INDIANA DEPARTMENT OF TRANSPORTATION

STANDARDS COMMITTEE MEETING

REVISED AGENDA

January 15, 2009 Standards Committee Meeting

STANDARD DRAWING NO. E 701-BPIL-02

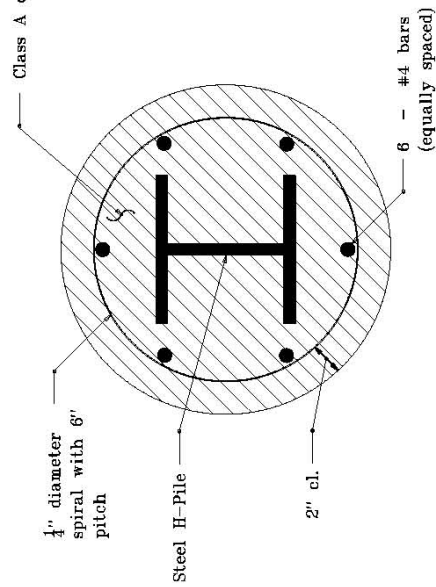
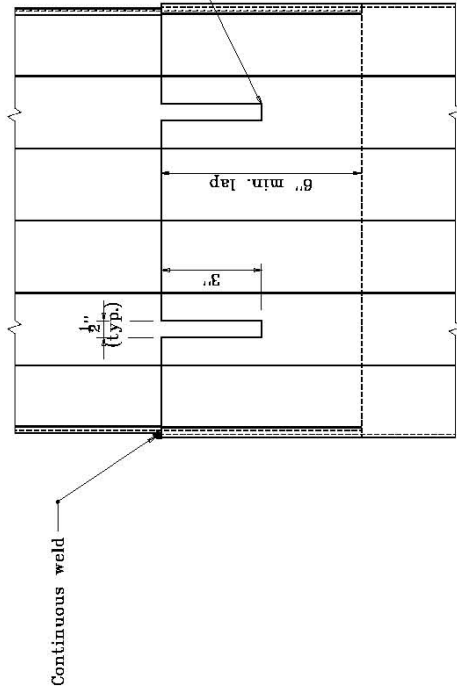
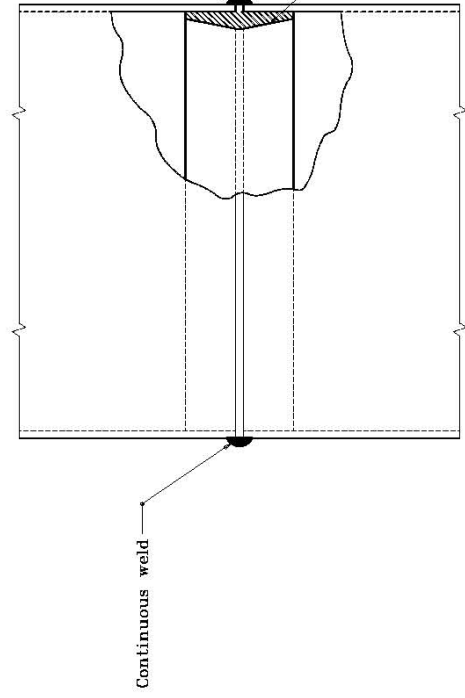
~~ENCASED~~ REINFORCED CONCRETE PILE DETAILS

REINFORCED CONCRETE ~~ENCASED~~ DETAIL

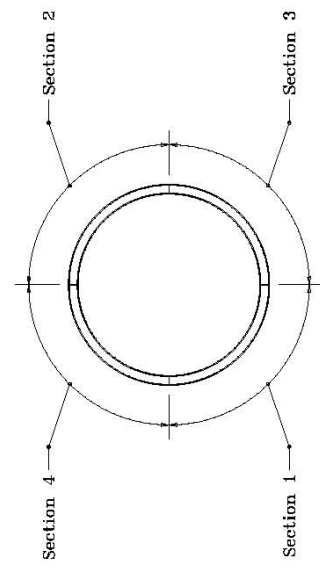
FOR FLUTED ~~SHELLS~~ PIPE

FOR ROUNDED PIPE

PIPE ~~IS~~

REVISION TO STANDARD DRAWING AND 2008 STANDARD SPECIFICATIONS
506-CCPP-01 CONCRETE PAVEMENT PATCH DETAILS

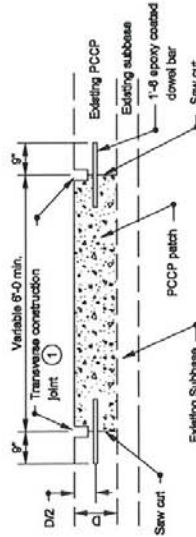
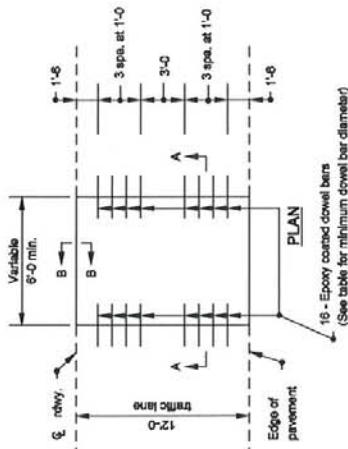
Item No.08-15-8
Mr. Heustis
Date: 01/15/09

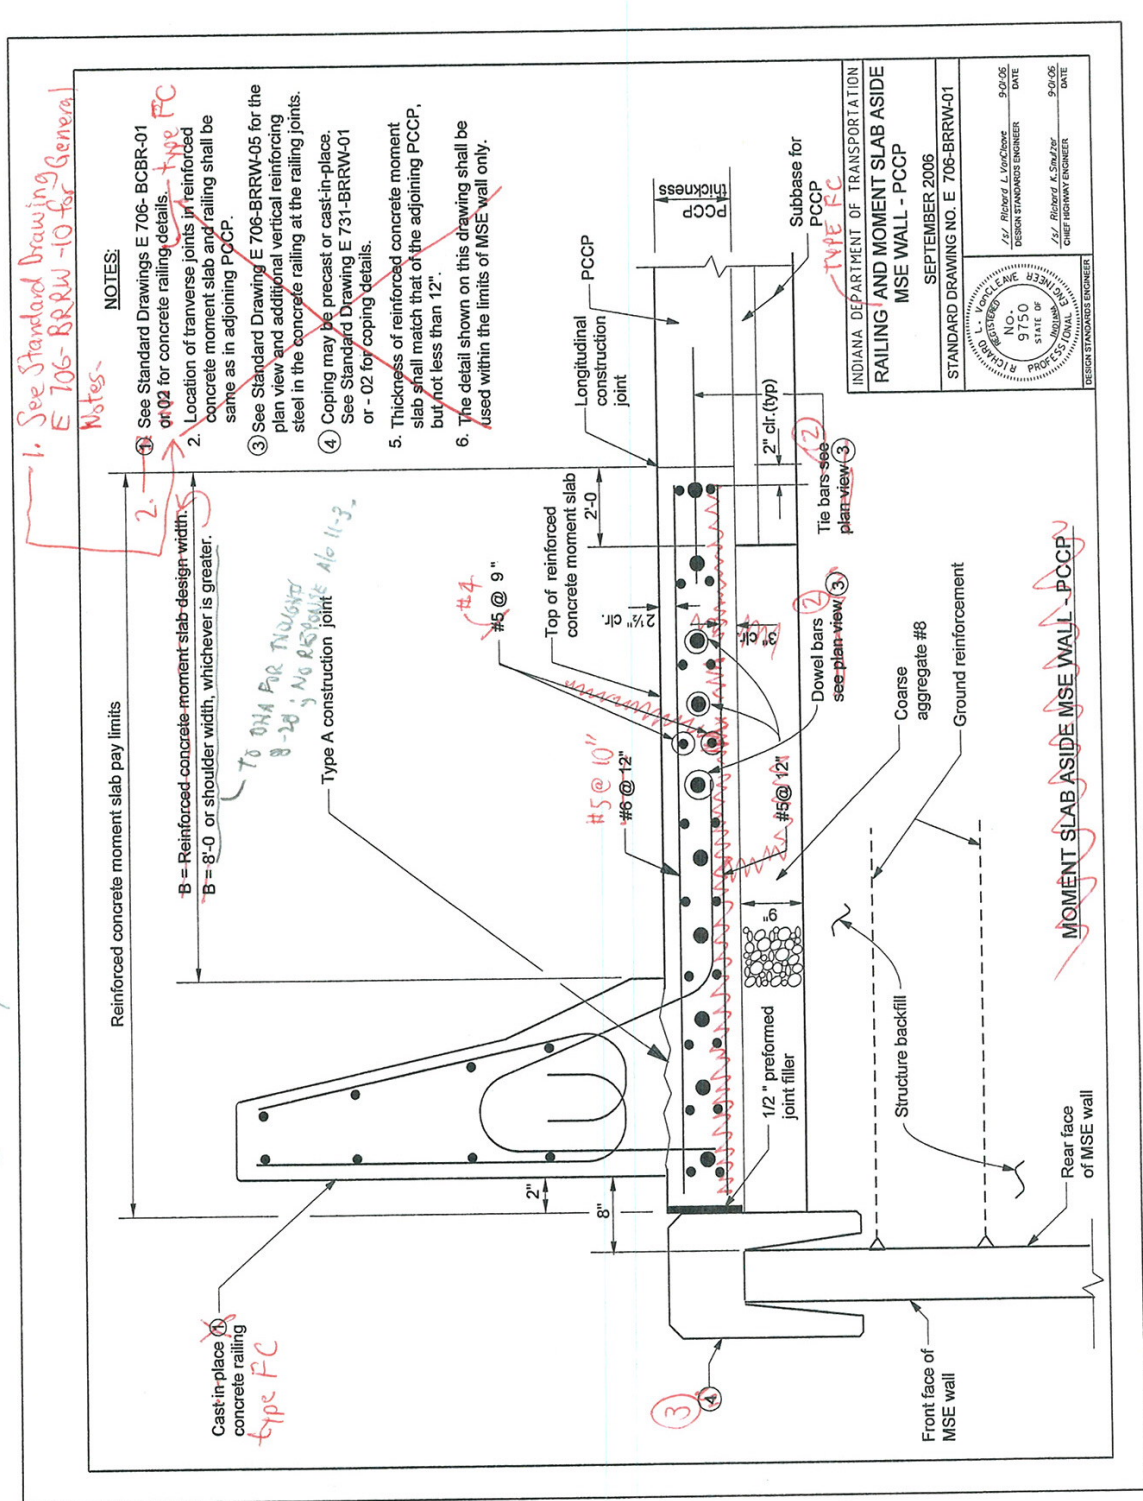
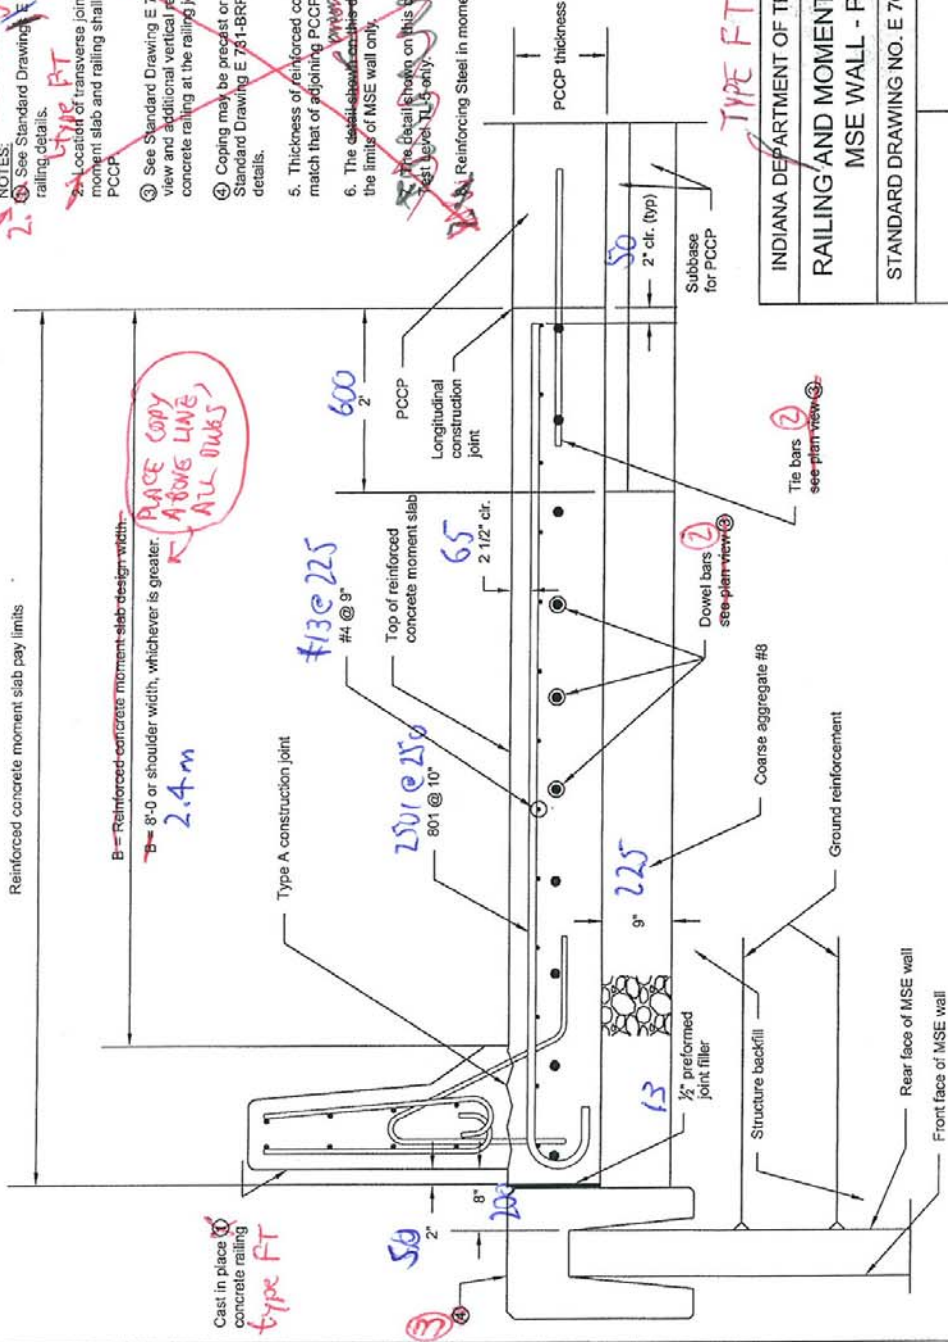
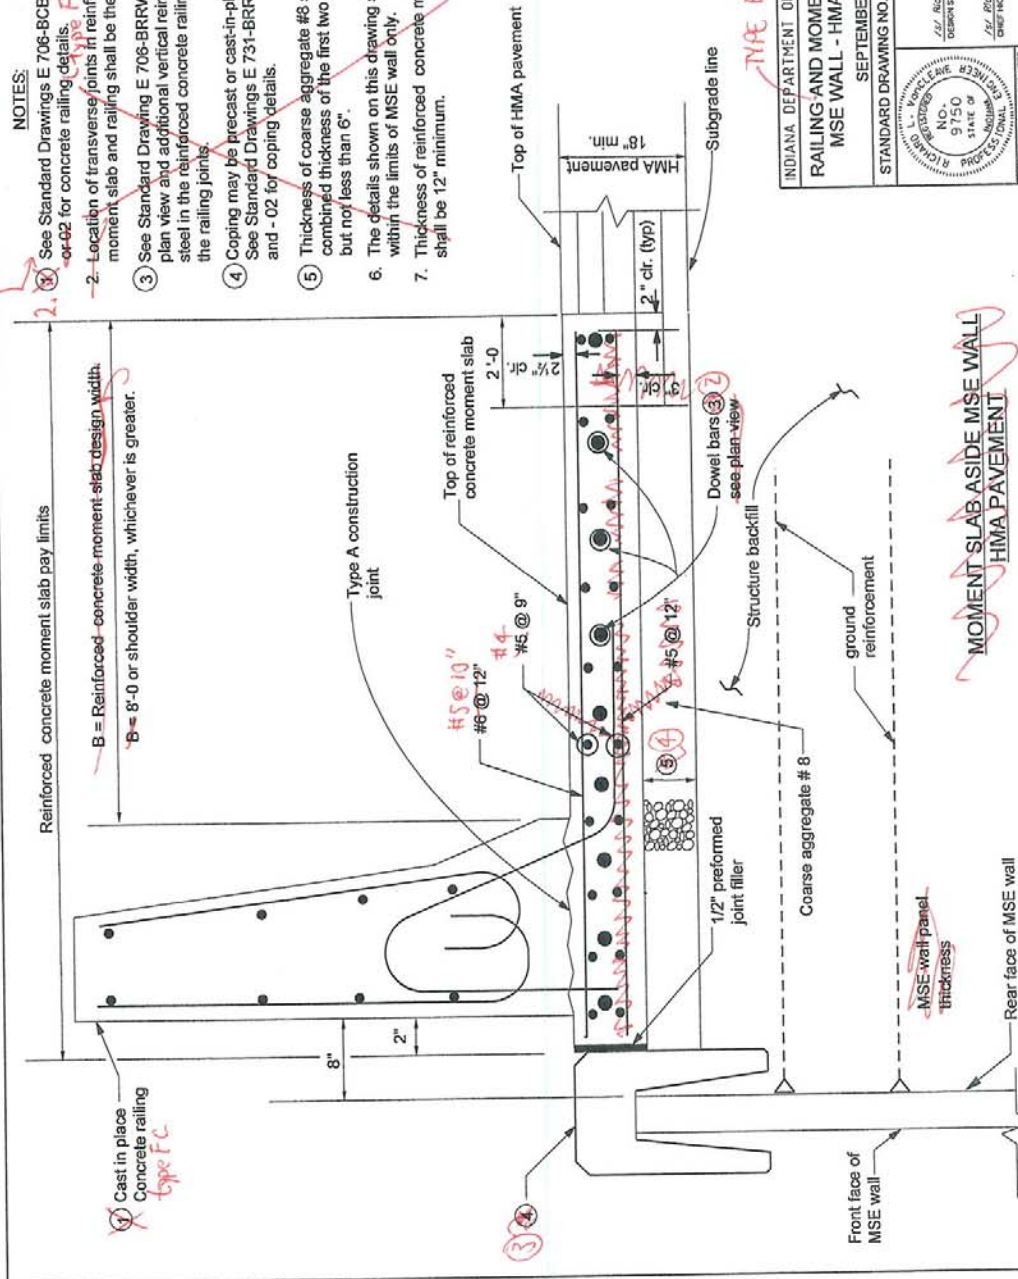
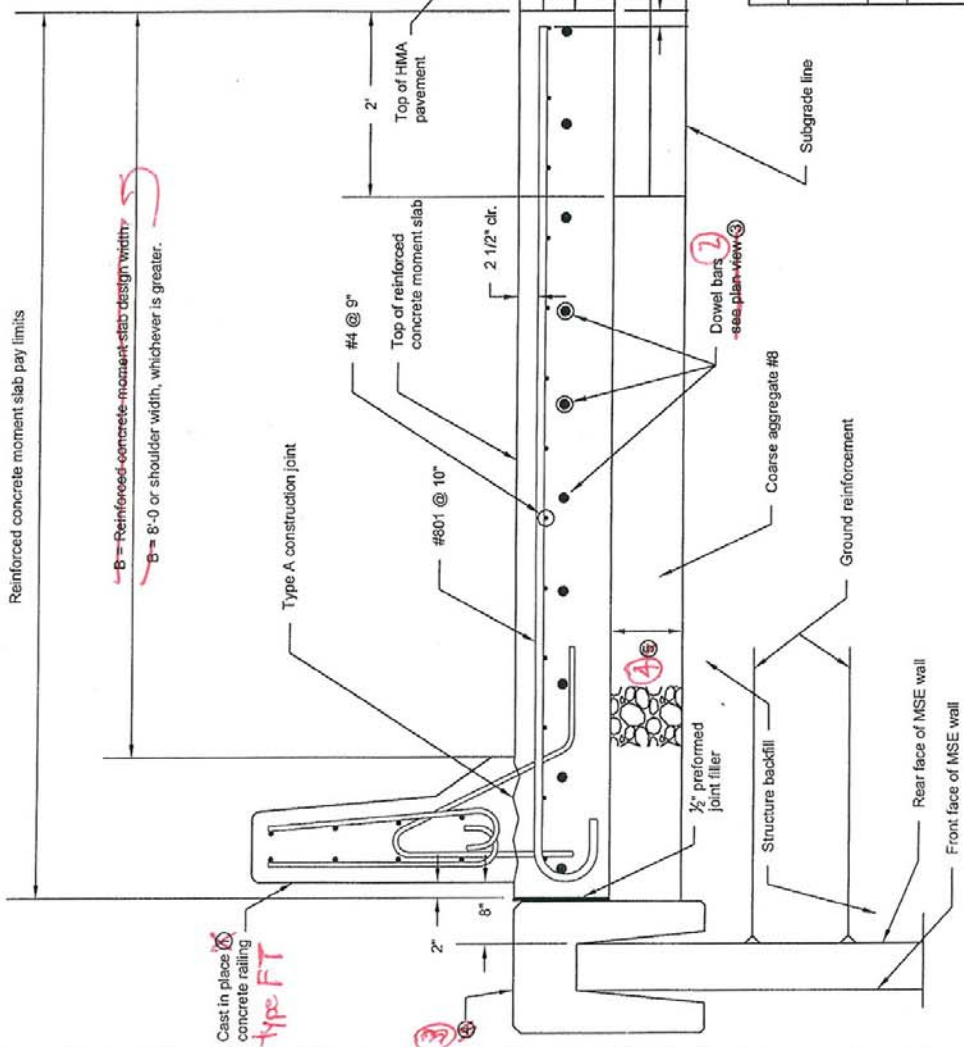
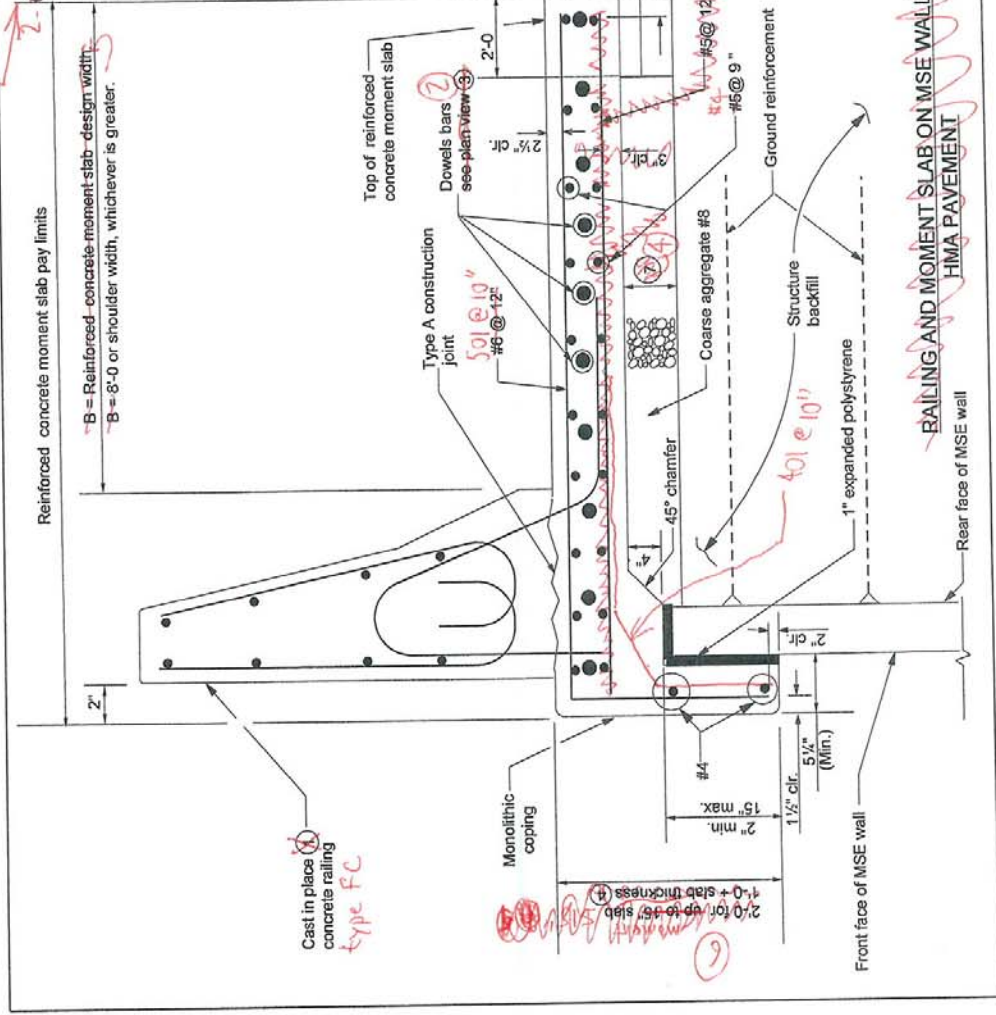
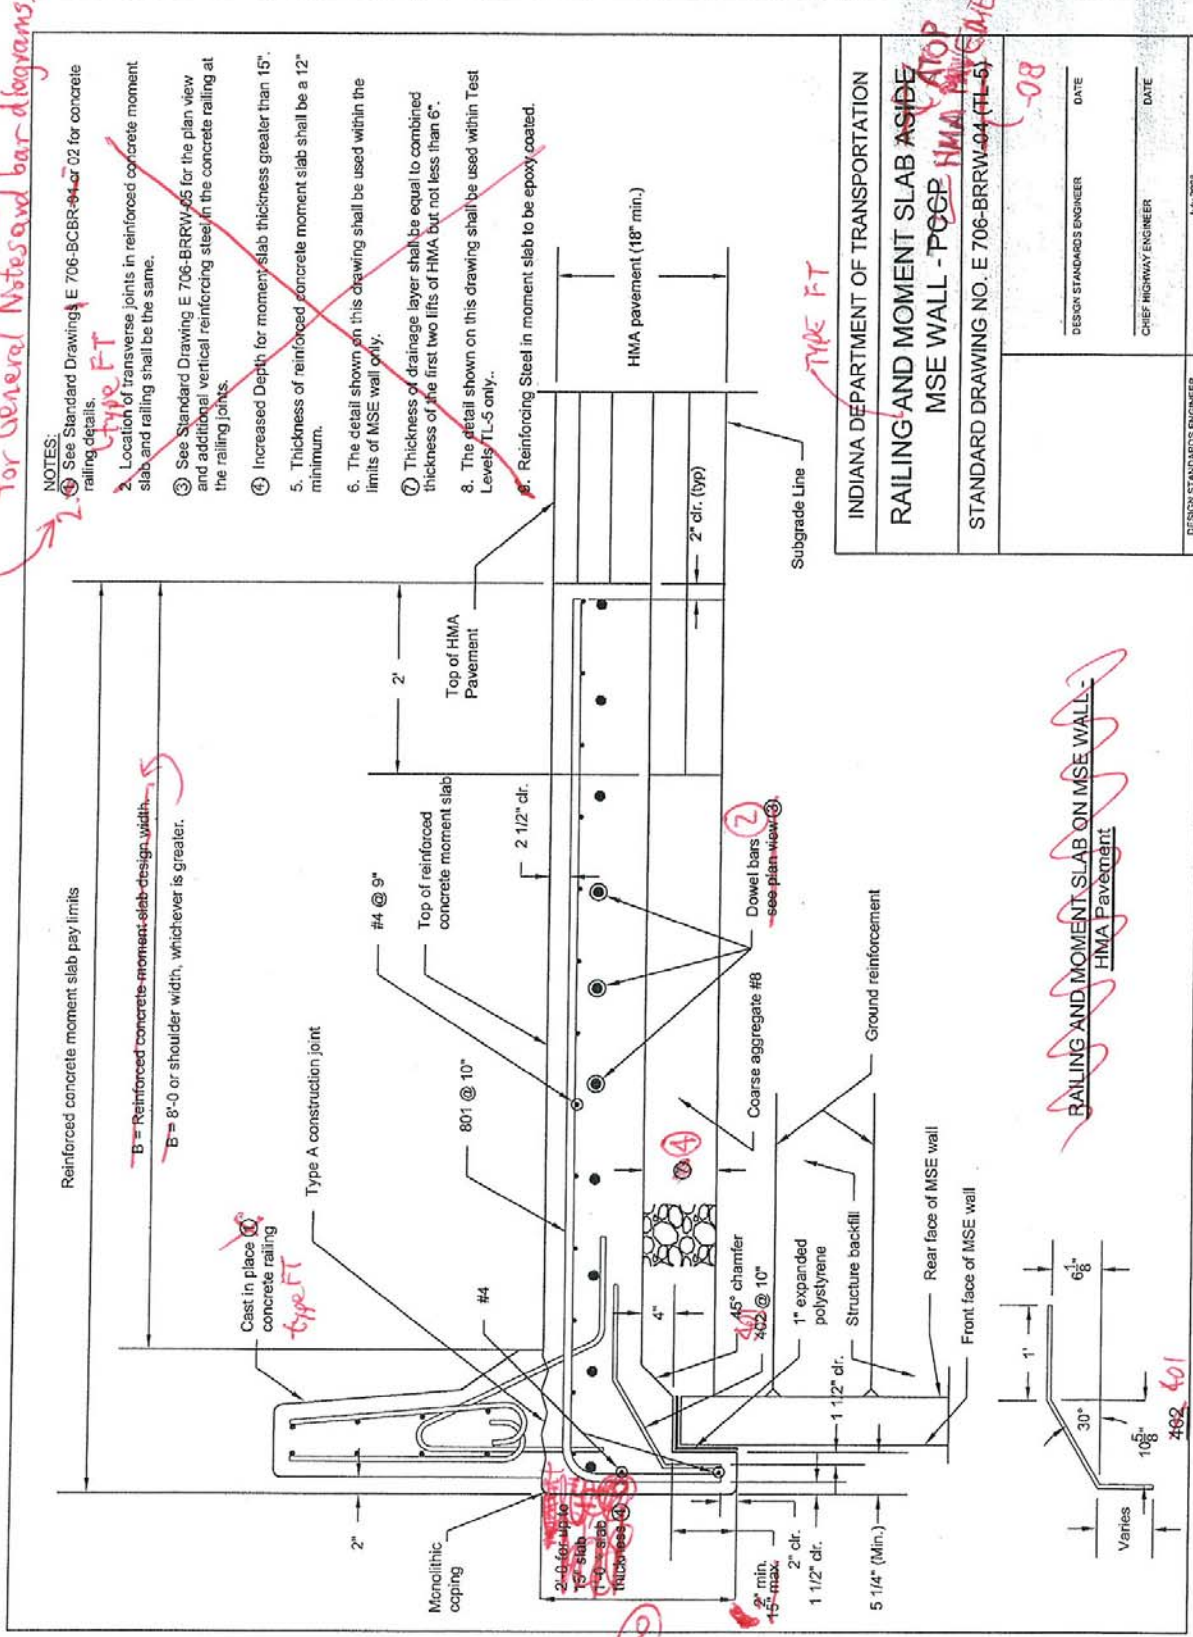
Existing standard drawings 706-BCBR-01, -02, and -04 for concrete bridge railings are being revised to identify the common- and truck-height railings by a type designation.

INDIANA DEPARTMENT OF TRANSPORTATION
RAILING TYPE FT AND MOMENT
SLAB AT MSE WALL

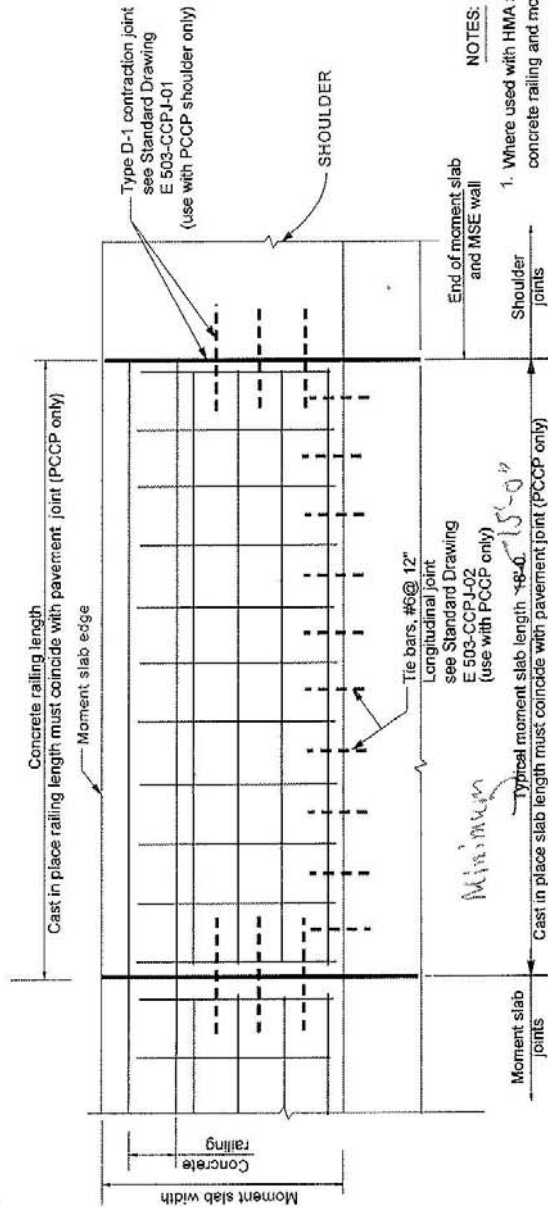
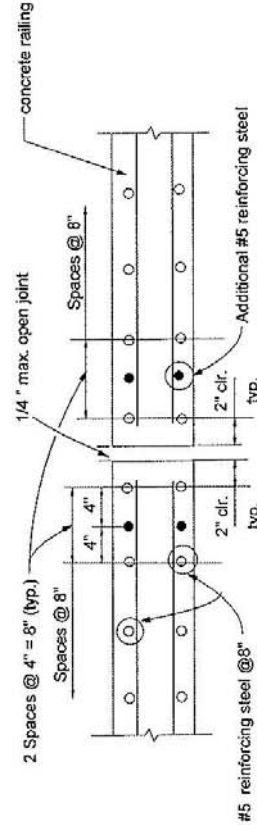
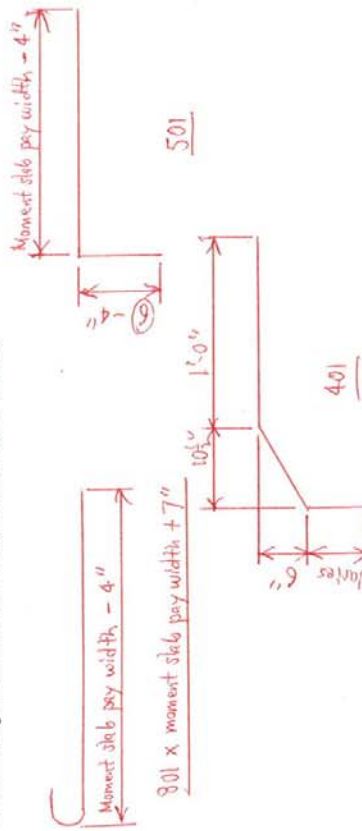
RAILING AND MOMENT SLAB ON MSE WALL - HMA Pavement

NEW 02/04
